# Access Compliance Report

## Public Rights-of-Way

### (Pedestrian Signals)

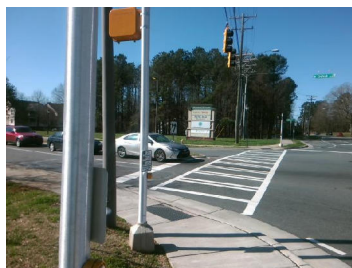
PROW/ADA: , R404.2, R404.7.2

Possible Solutions: Replace Signal Push Button With APS Button on New Post. Remove & Relocate Sign.
